12 - 2009
6905B
1/2" IMPACT WRENCH

SERVICE CHANGES

1. Changes on Pin 4

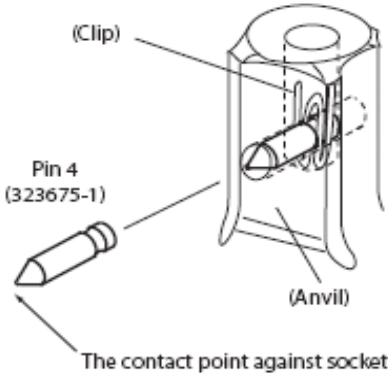
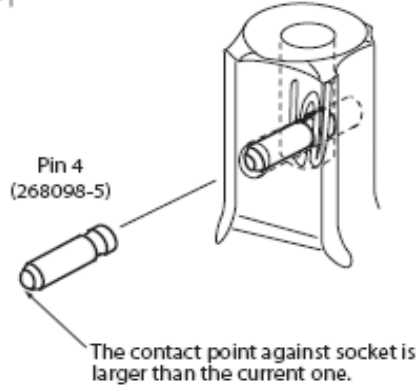
Item No.	Description	Type 1	Type 2
903	PIN 4	323675-1 (Round head)	268098-5 (Flat head)

TYPE1:

Removing way of the socket:
Simply pull the socket off.

TYPE2:

Removing way of the socket:
Depress the detent pin through the hole in the socket and pull the socket off the anvil.

*For easy conversion, use Flat Pin 4 Set (194485-1) (Item No. A05).
